Application for Licence Amendment

Licence Number	L8148/2006/4
Licence Holder	Koolan Iron Ore Pty Ltd
ACN	099 455 277
File Number	APP-0026533
Premises	Koolan Iron Ore Mine and Port Facility Mining Tenements M04/416, M04/417, L04/29 and L04/68 KOOLAN ISLAND (BUCCANEER ARCHIPELAGO) WA 6733
Date of Report	03/06/2025
Decision	Revised licence granted

Figure 1: Emission Points in relation to Ecological Protection Areas

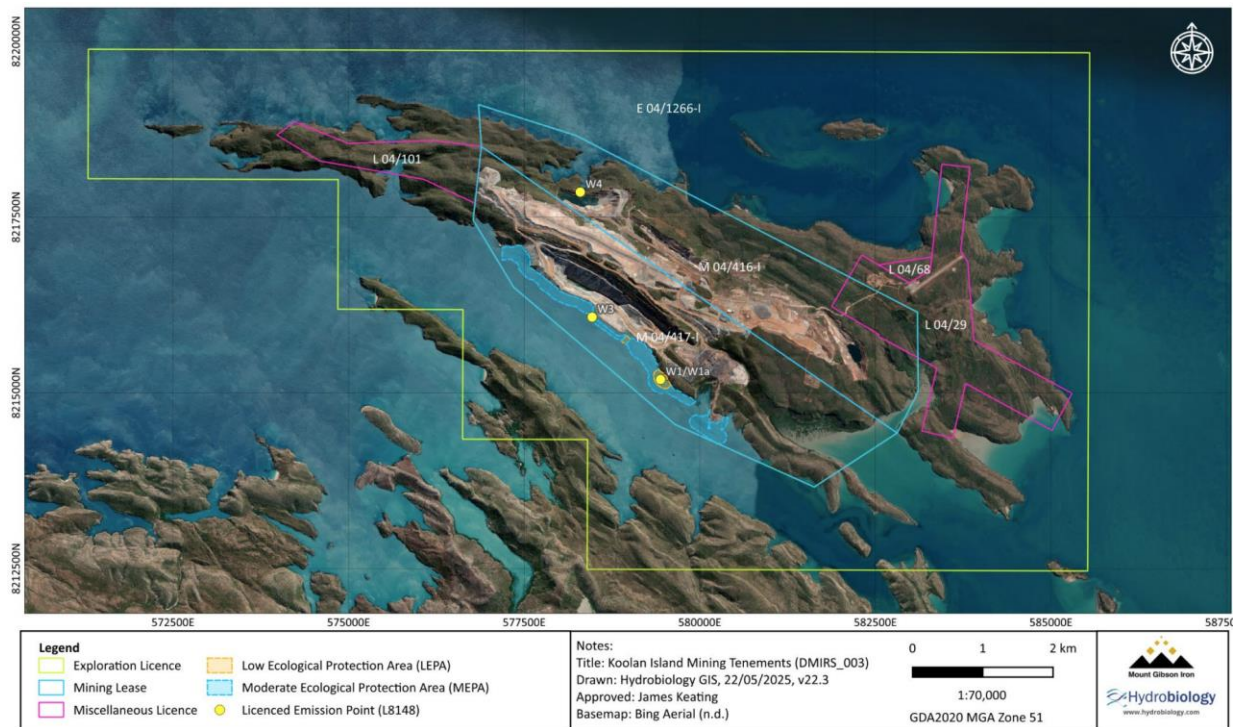
Figure 1 Emissions Points in relation to Ecological Protection Areas	Refer to Schedule 3 of this response for an updated map with emission point W2 removed.	Noted.
Figure 2 Distance to sensitive	Refer to Schedule 4 of this response for an updated map with emission point W2 removed.	Noted.

Figure 2: Distance to sensitive receptors

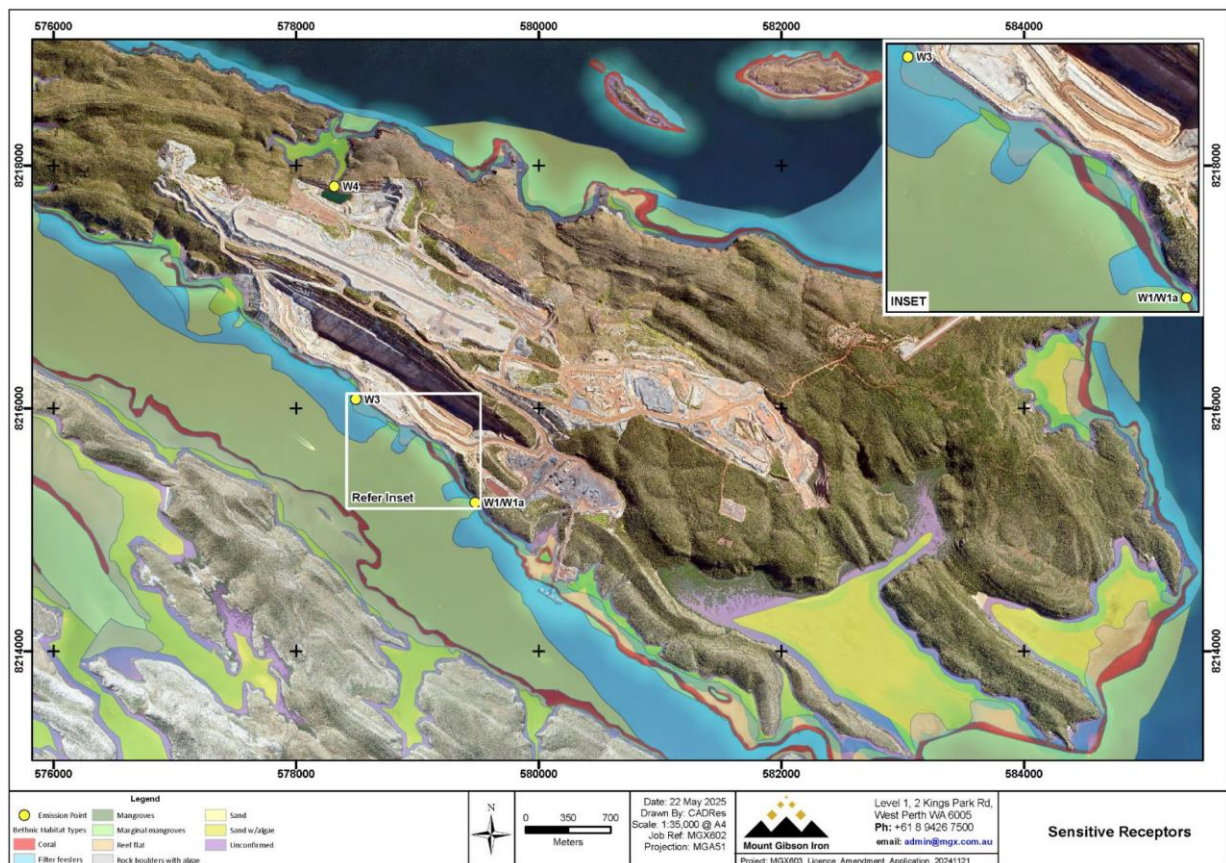
Condition	Summary of Licence Holder's comment	Department's response
receptors

Figure 4: Flow pathways for routine and contingency discharge via W1 and W1a emission points

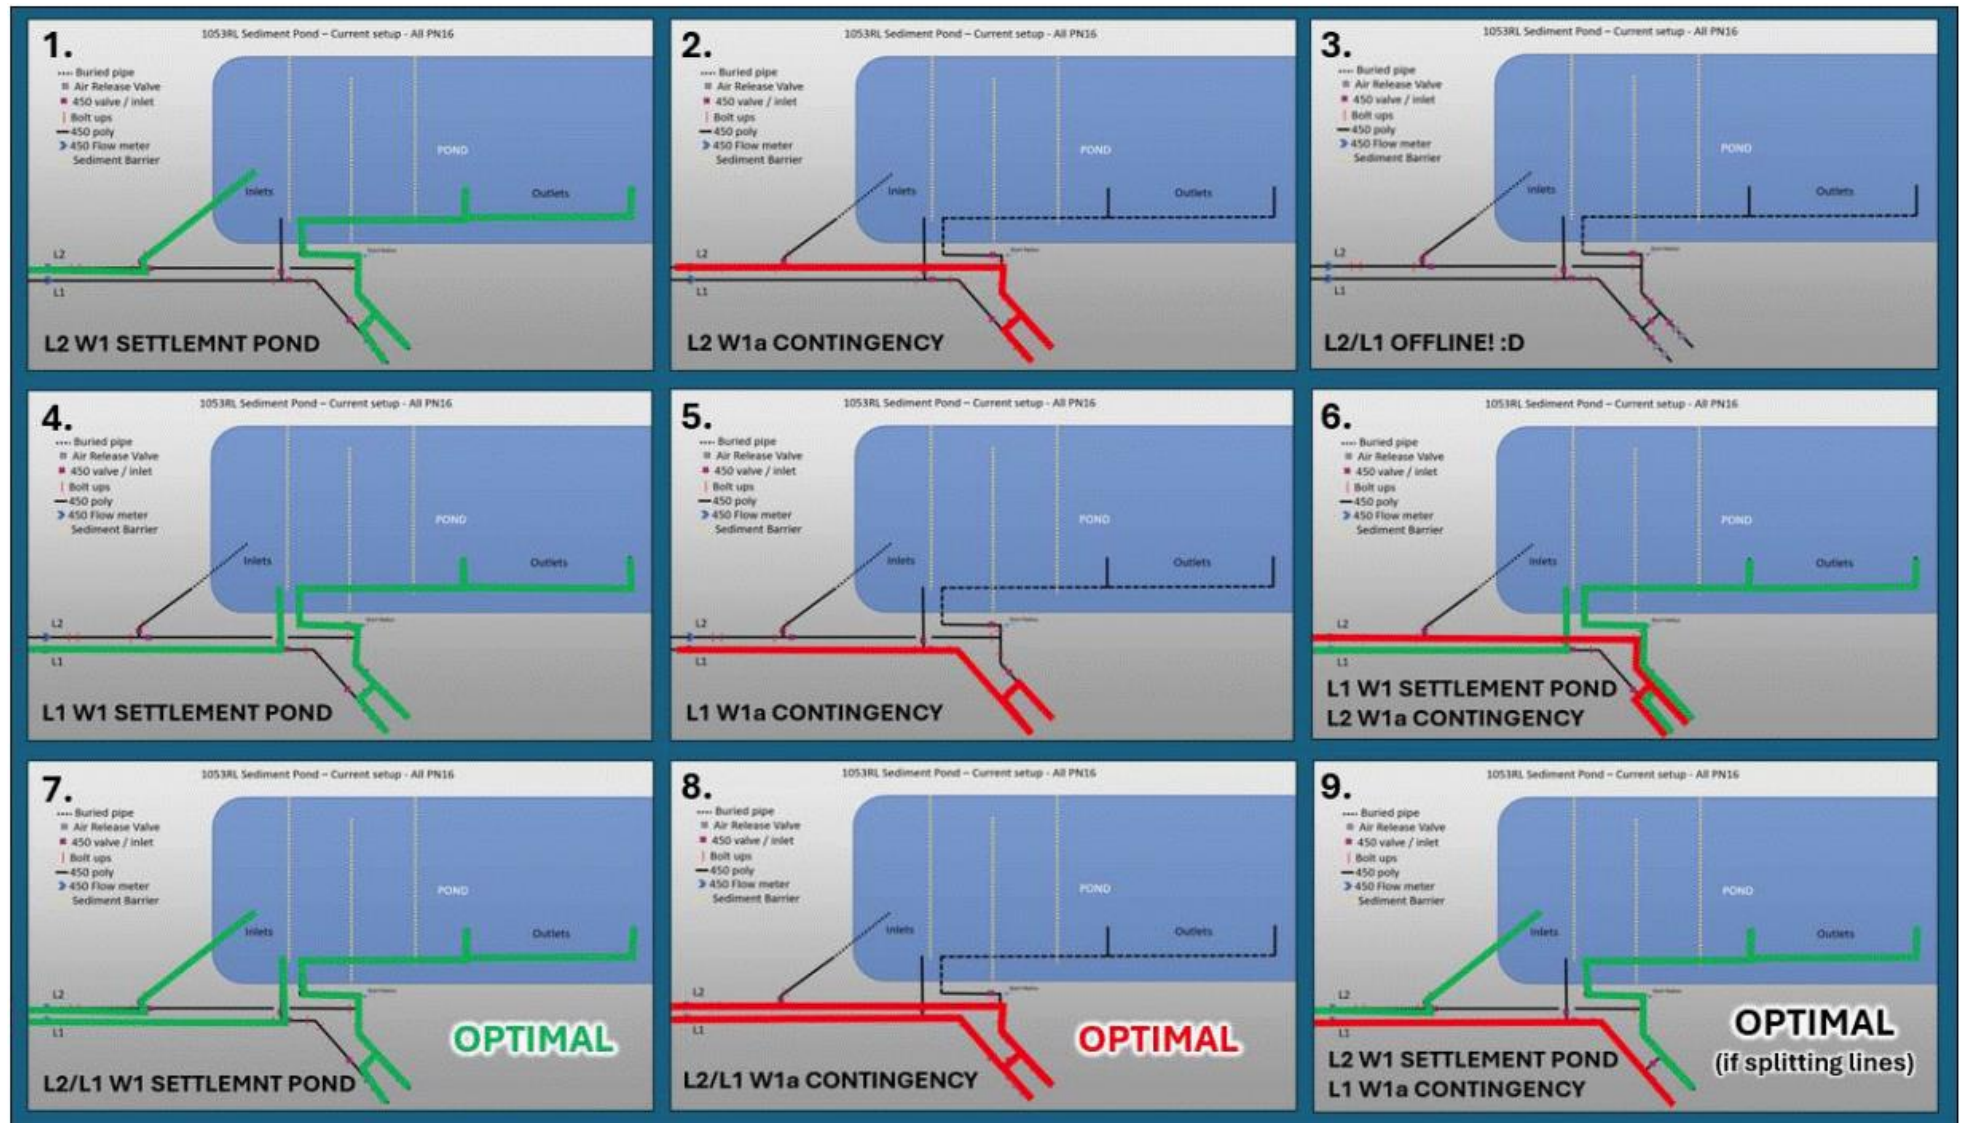
- Settlement of mine dewater should be heavily incentivised, and contingency discharge should be prevented as much as possible through the inclusion of a 'contingency discharge' definition and limits to volumetric flow leaving the emission points.

It is the intention here that contingency discharge events are disincentivised and where they do occur, settlement is undertaken as much as possible. Figure 4 in Appendix 1 provides the flow pathway options for the W1 and W1a emission points. Limiting flow rates are expected to reduce the likelihood that options where the settlement pond is bypassed completely are limited to emergency situations or where no viable alternative is available.
